**Responses to Public Comments  
Submitted on the Draft Regulatory Guide  
for Evaluation of Electromagnetic and  
Radio-Frequency Interference in Safety-  
Related I&C Systems  
(DG-1029)**

**September, 1998**

**U.S. NUCLEAR REGULATORY COMMISSION  
OFFICE OF NUCLEAR REGULATORY RESEARCH  
Division of Systems Technology  
Control, Instrumentation, and Human Factors Branch**

Figure 1 Comparison of low-frequency conducted susceptibility envelopes

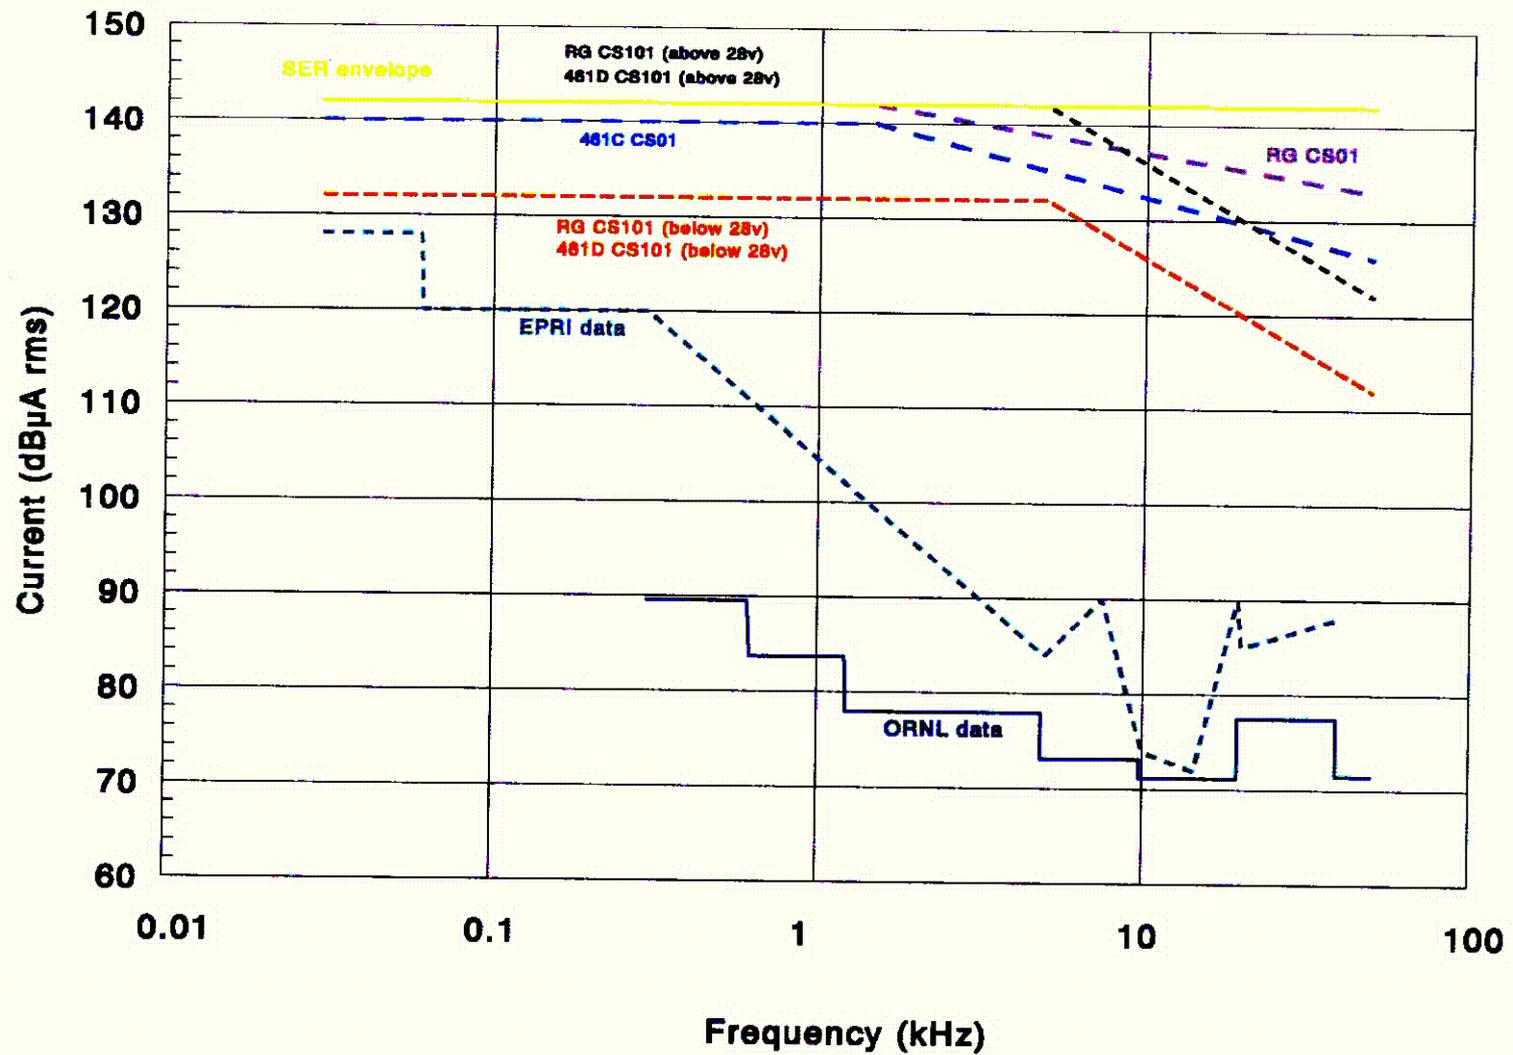
Figure 1 provides a comparative plot of the RG (i.e., DG-1029) envelopes for CS101 and CS01, the baseline MIL-STD envelopes, the corresponding envelope endorsed by the SER on EPRI TR-102323, and the plant emissions data presented in NUREG/CR-6436 and EPRI TR-102323. The RG and MIL-STD envelopes are converted from voltage to current for comparative purposes based on an assumption of 0.5  $\Omega$  impedance. It is seen that the RG and SER envelopes are similar in level. The most notable exception is the less restrictive RG envelope for equipment with source voltages at or below 28 V. As can be observed from the plot, this envelope only provides a 4 dB $\mu$ A margin above the highest measured plant emissions data reported in EPRI TR-102323. However, in the frequency range below 120 Hz, the 4 dB margin is judged to be sufficient for two reasons. First, the starting frequency for testing of ac powered equipment is specified to be the second harmonic so the ac limit does not apply over the frequency range with the 4

dB margin. Second, although the envelope does apply over the frequency range with the 4 dB margin for dc powered equipment, the bounding plant data resulted from ac powered equipment according to EPRI so adequate margin for dc powered equipment is probable.

Figure 2 Comparison of high-frequency conducted susceptibility envelopes

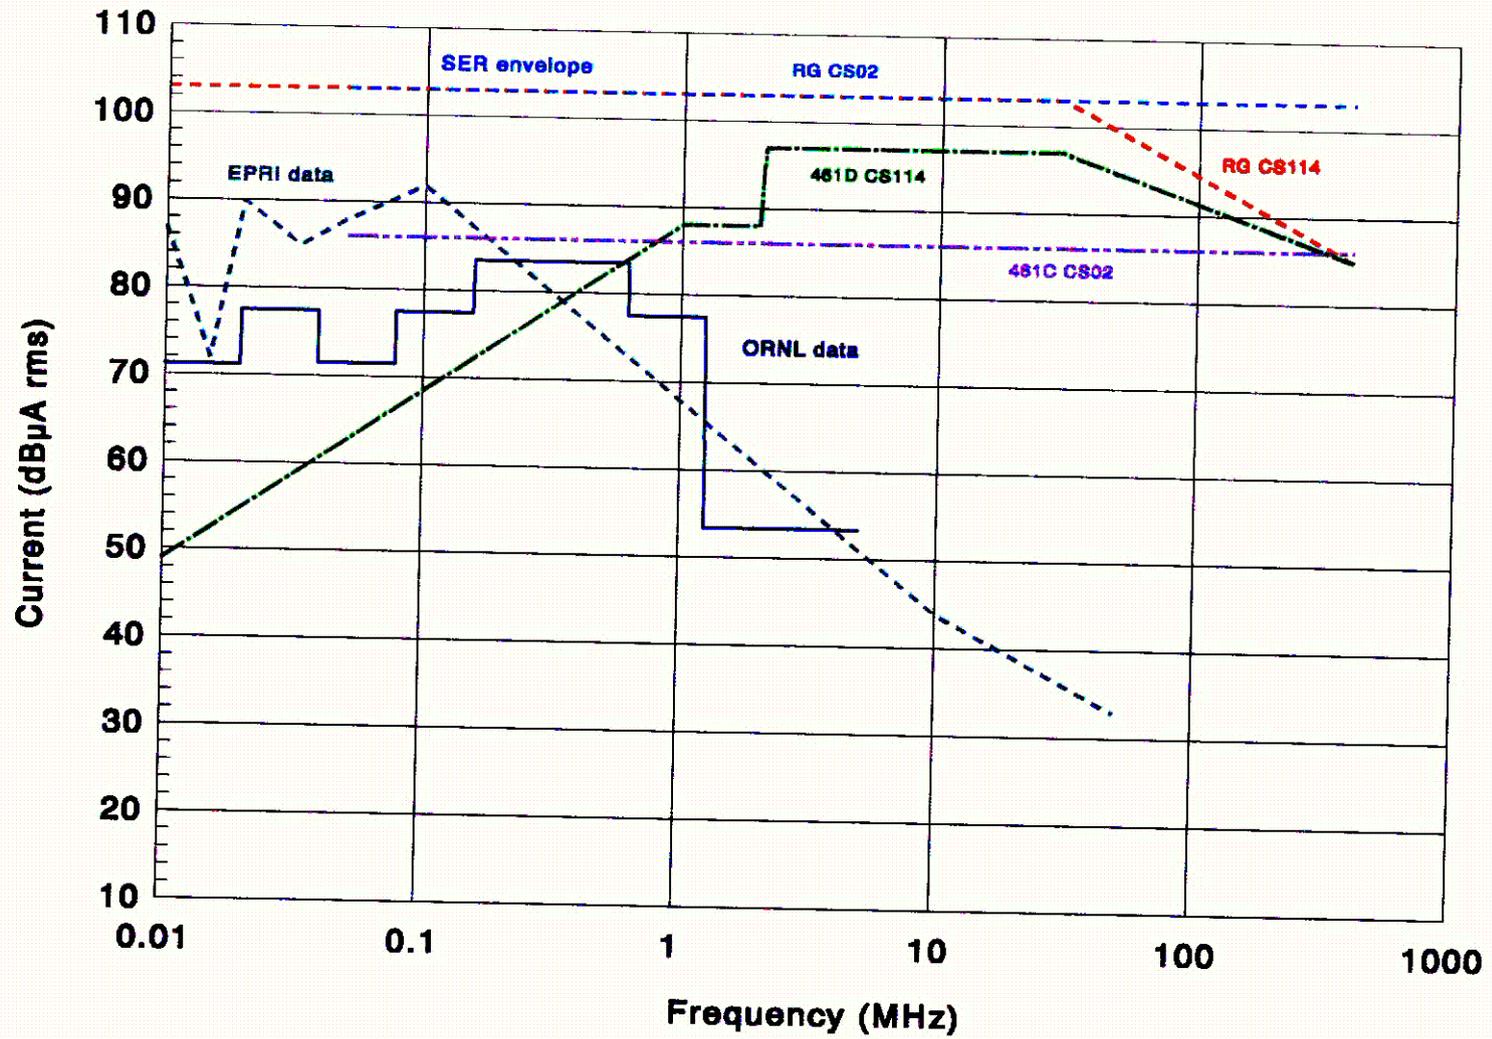
Figure 2 provides a comparative plot of the RG (i.e., DG-1029) envelopes for CS114 and CS02, the baseline MIL-STD envelopes, the corresponding envelope endorsed by the SER on EPRI TR-102323, and the plant emissions data presented in NUREG/CR-6436 and EPRI TR-102323. The RG and MIL-STD envelopes for CS02 are converted from voltage to current for comparative purposes based on an assumption of 50  $\Omega$  impedance. The conflict between the MIL-STD emissions envelopes and the plant emissions data is clearly seen. For this reason, the RG envelopes are adjusted from their MIL-STD basis. It is also seen that the RG and SER envelopes are similar in level. The most notable exception is the less restrictive RG envelope CS114 above 30 MHz. This difference

Figure 3 Comparison of low-frequency radiated susceptibility envelopes

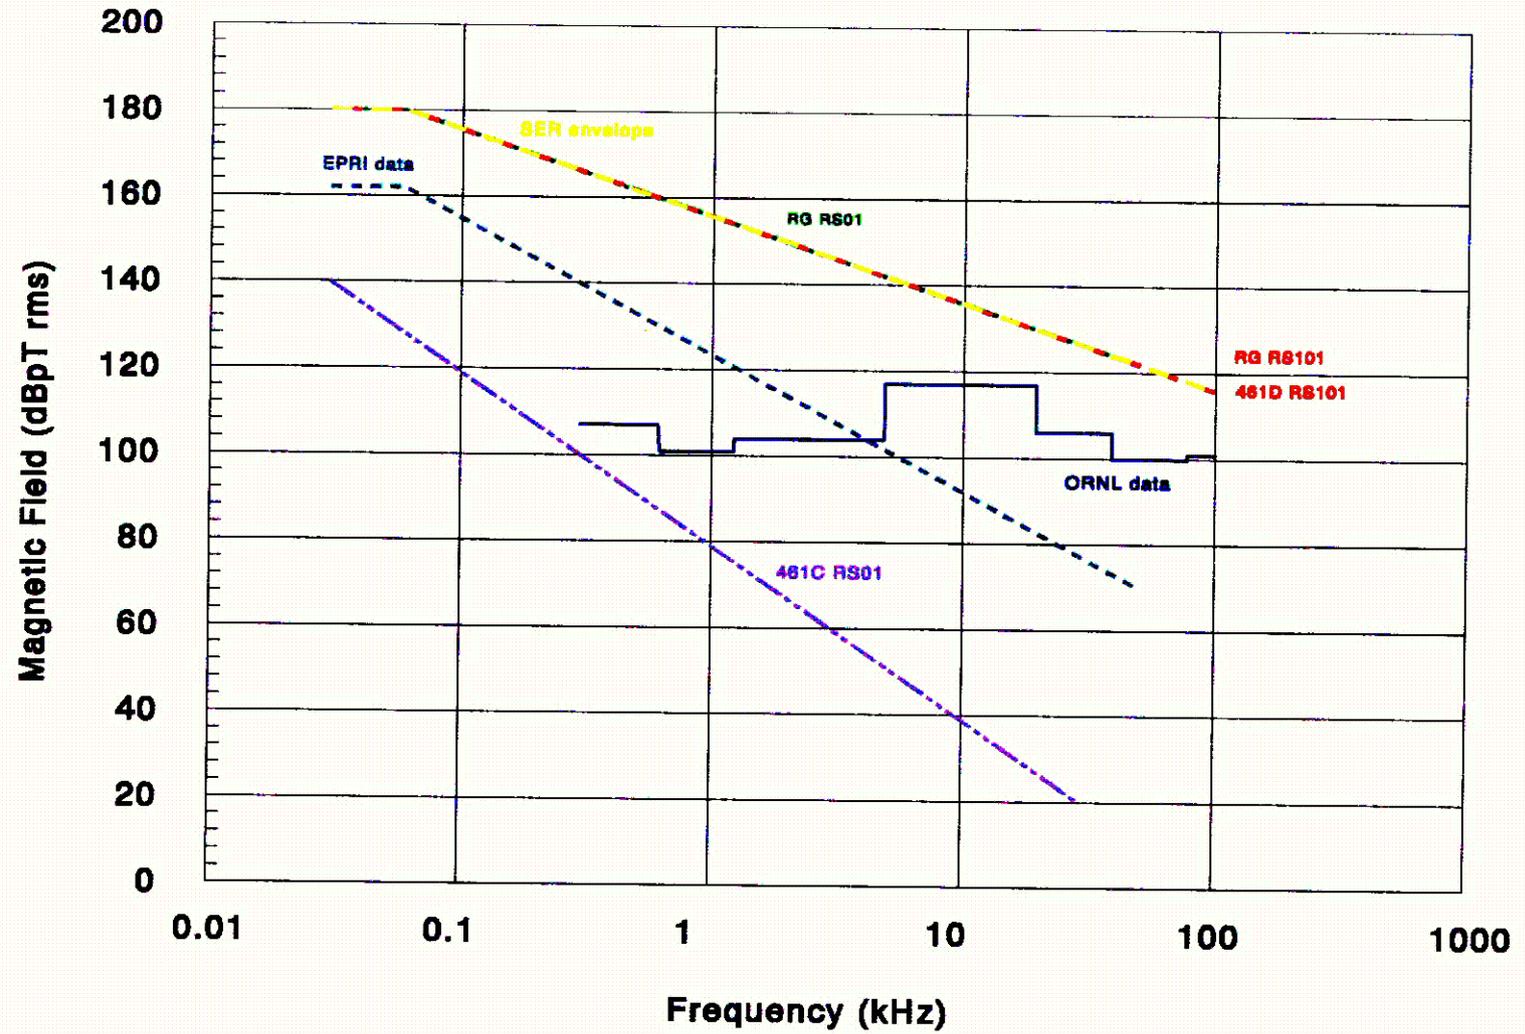
Figure 3 provides a comparative plot of the RG (i.e., DG-1029) envelopes for RS101 and RS01, the baseline MIL-STD envelopes, the corresponding envelope endorsed by the SER on EPRI TR-102323, and the plant emissions data presented in NUREG/CR-6436 and EPRI TR-102323. The conflict between the MIL-STD emissions envelopes for RS01 and the plant emissions data is clearly seen. For this reason, that RG envelope is adjusted from its MIL-STD basis. It is also seen that the RG and SER envelopes are identical.

Figure 4 Comparison of high-frequency radiated susceptibility envelopes

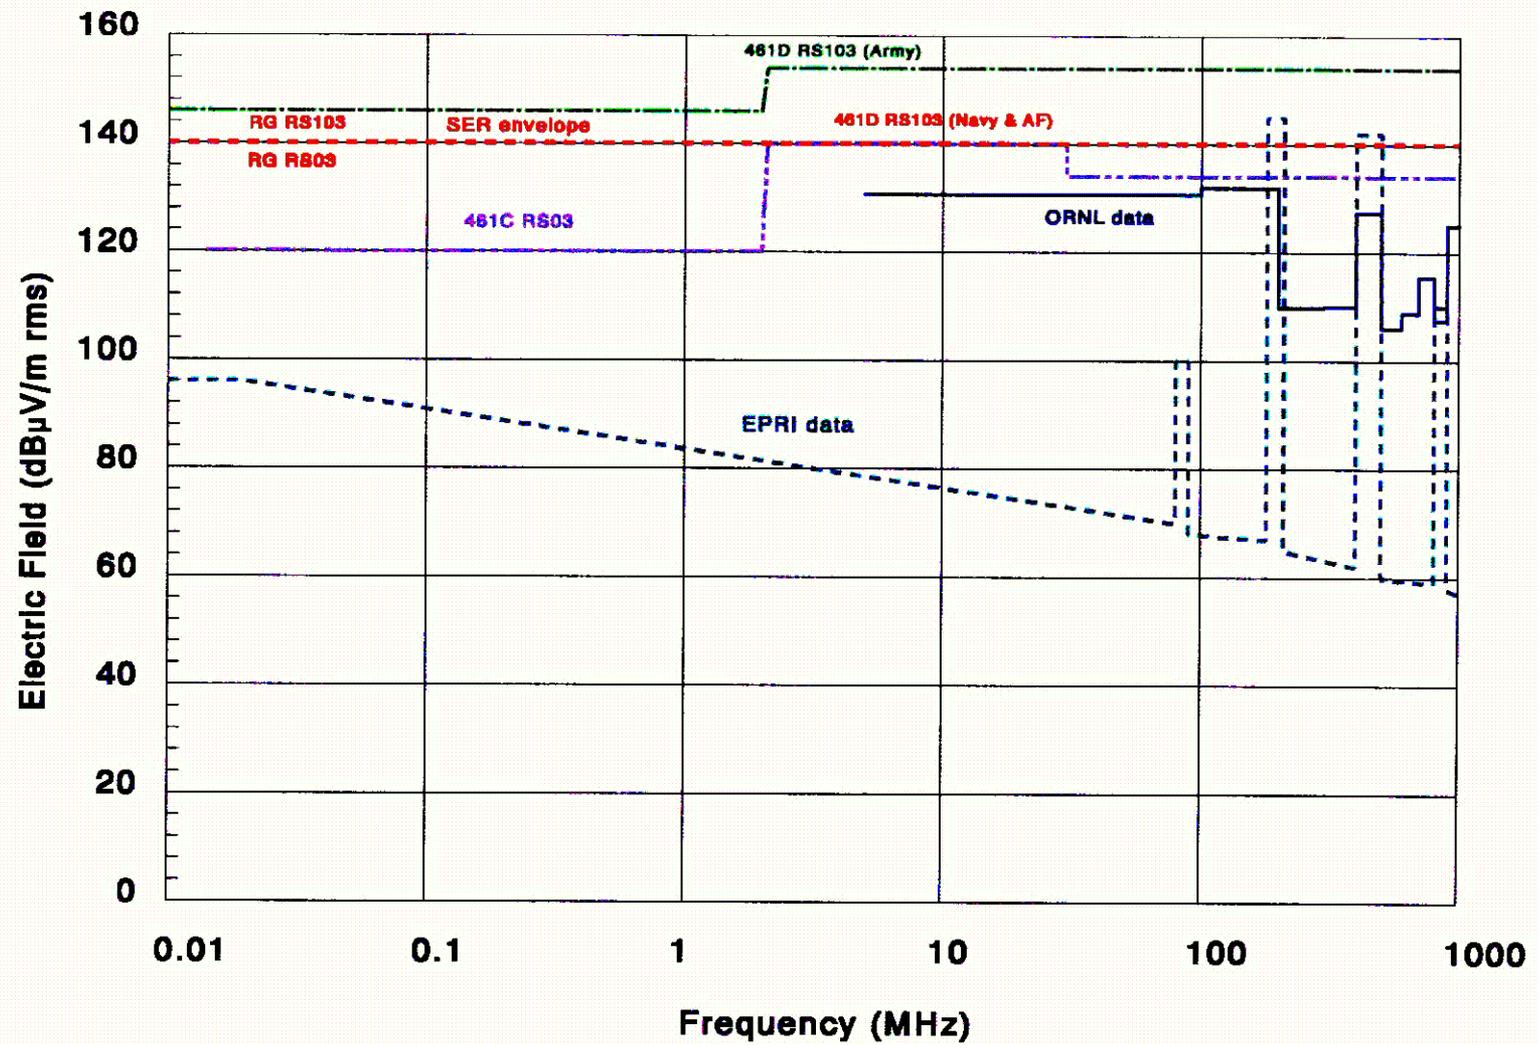
Figure 4 provides a comparative plot of the RG (i.e., DG-1029) envelopes for RS103 and RS03, the baseline MIL-STD envelopes, the corresponding envelope endorsed by the SER on EPRI TR-102323, and the plant emissions data presented in NUREG/CR-6436 and EPRI TR-102323. The MIL-STD 461D RS103 envelope for Army ground facilities is shown to illustrate difference that can result if administrative controls are not in place. The RG envelope is identical to the MIL-STD envelope for Navy and Air Force facilities. The conflict between the MIL-STD emissions envelopes for RS03 and the plant emissions data is clearly seen. For this reason, that RG envelope is adjusted from its MIL-STD basis. It is also seen that the RG and SER envelopes are identical.

Figure 5 Comparison of low-frequency conducted emissions envelopes

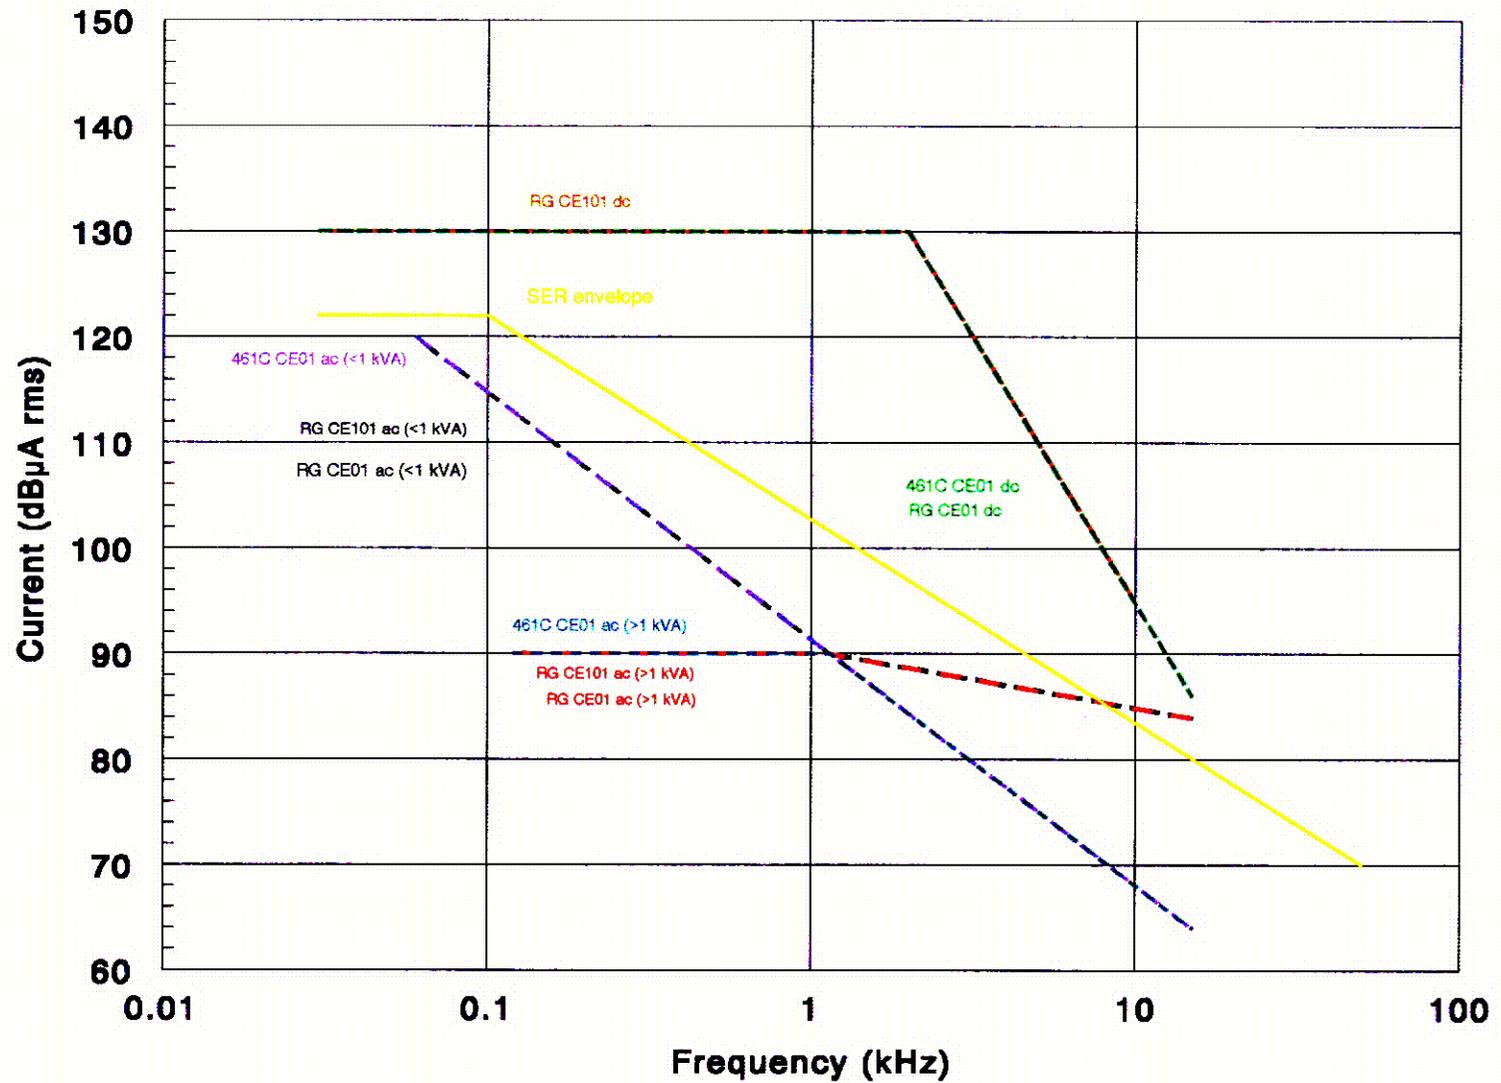
Figure 5 provides a comparative plot of the RG (i.e., DG-1029) envelopes for CE101 and CE01, the baseline MIL-STD envelopes, and the corresponding envelope endorsed by the SER on EPRI TR-102323. The envelopes for ac power leads are less restrictive than the MIL-STD envelopes in the higher frequency band (> 1.15 kHz) because of adjustments to promote consistency between the conducted emissions operating envelopes at 10 kHz for CE101 and CE102 and at 15 kHz for CE01 and CE03. The RG emissions envelope for dc power leads is less restrictive than the corresponding SER emissions envelope. The RG emissions envelopes for ac power leads are somewhat more restrictive than the corresponding SER emissions envelope. Nevertheless, the power quality basis for ac-power-lead emissions envelopes provides an appropriate foundation for the RG envelopes.

Figure 6 Comparison of high-frequency conducted emissions envelopes

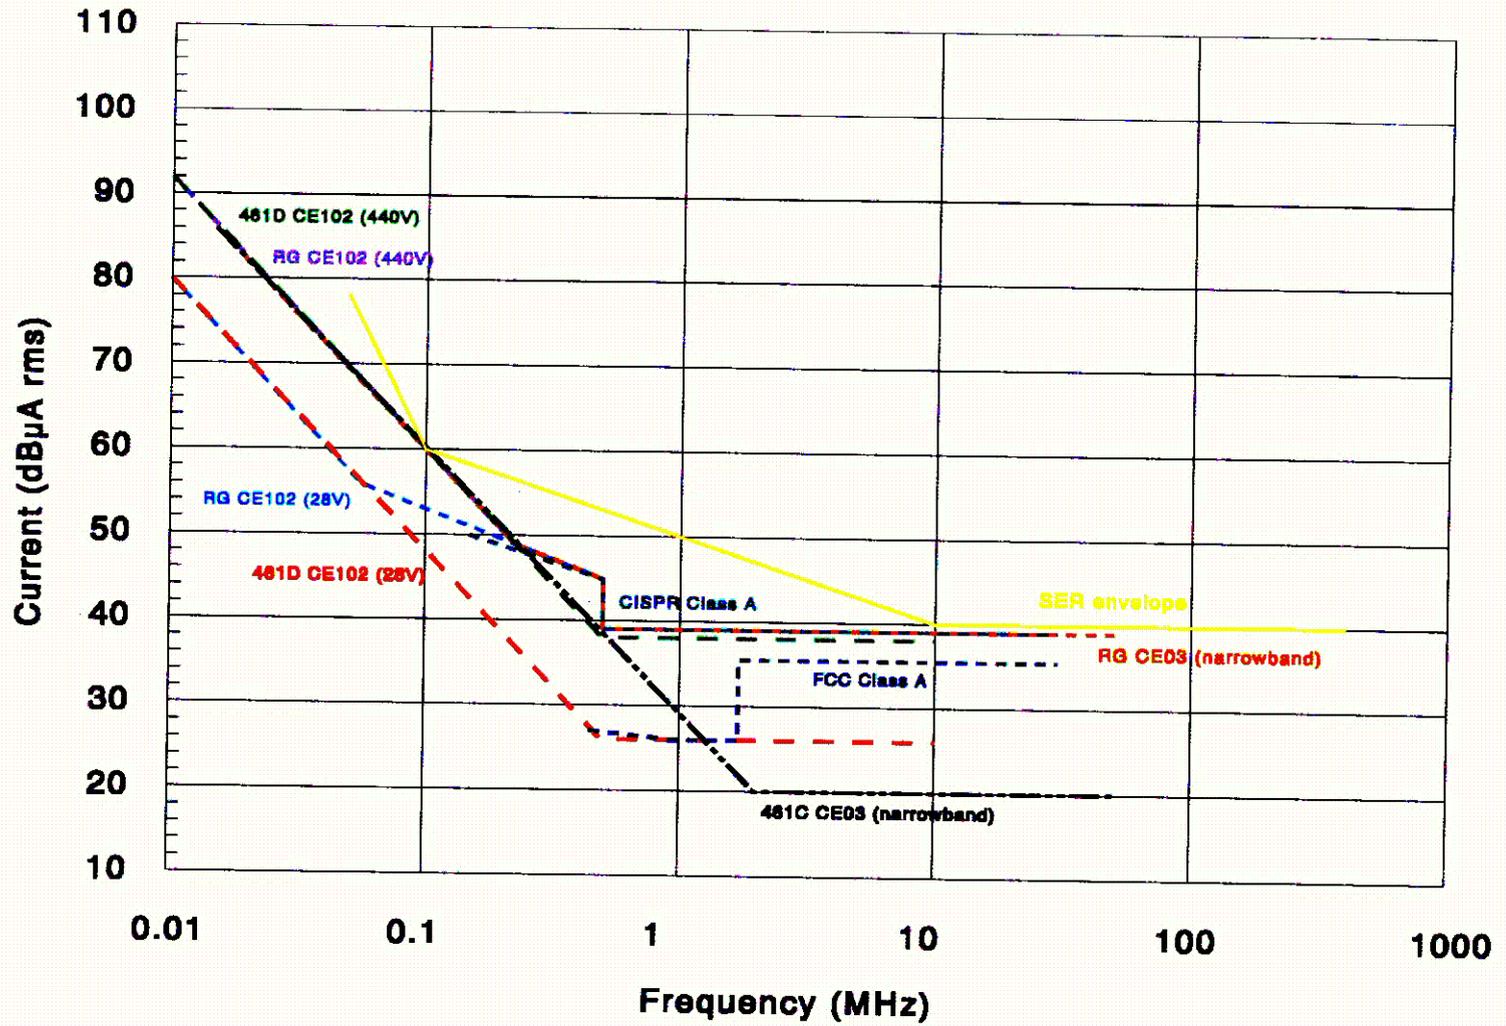
Figure 6 provides a comparative plot of the RG (i.e., DG-1029) envelopes for CE102 and CE03, the baseline MIL-STD envelopes, the corresponding envelope endorsed by the SER on EPRI TR-102323, and the Class A equipment emissions limits for CISPR and FCC Part 15. The RG and MIL-STD envelopes for CE102 are converted from voltage to current for comparative purposes based on the test apparatus impedance established in MIL-STD 462D. The CISPR and FCC limits are converted from voltage to current for comparative purposes based on the test apparatus impedance defined for those test methods. The RG envelopes completely encompass the CISPR and FCC conducted emissions limits. The RG envelopes are slightly more restrictive than the corresponding SER envelope. Nevertheless, the power quality basis for the low frequency component of the emissions envelopes and the industrial emissions limit basis for the high frequency component of those envelopes provide an appropriate foundation for the RG envelopes for CE102 and CE03.
